**SUBJECT: NEW VEHICLE DEMONSTRATION / DELIVERY HOLD -
 Safety Recall 18S08 - *Supplement #1***
 Certain 2014 through 2018 Model Year Fusion and MKZ Vehicles
 Steering Wheel Attachment Bolt Replacement

**NEW VEHICLE DEMONSTRATION / DELIVERY HOLD -
Safety Recall 18S08 - Supplement #1**
Certain 2014 through 2018 Model Year Fusion and MKZ Vehicles
Steering Wheel Attachment Bolt Replacement

FIGURE 1

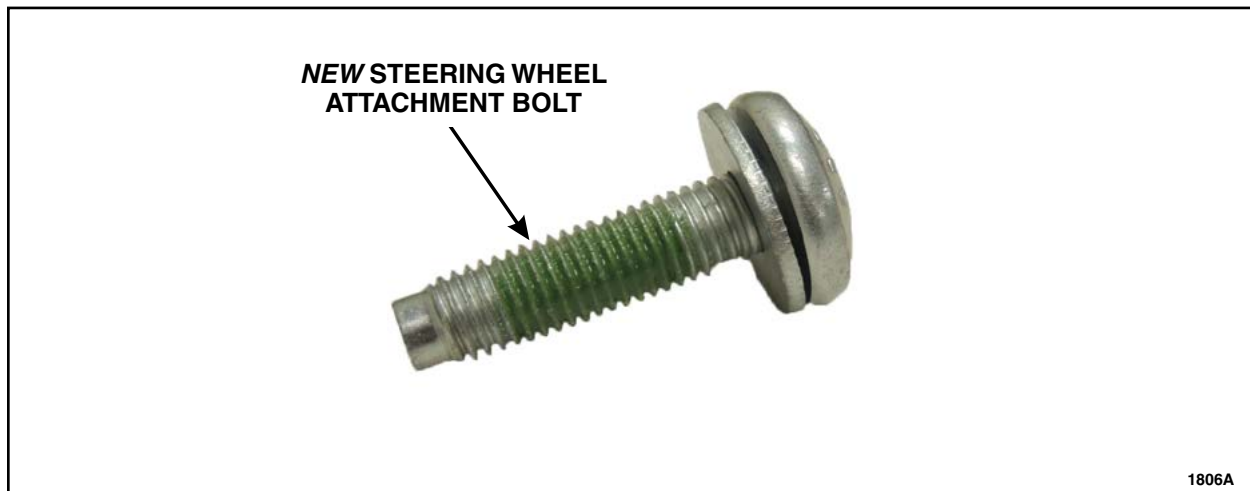
1. Replace the steering wheel attachment bolt. Please follow the Workshop Manual (WSM) procedures in Section 211-04 - steering wheel removal and installation.
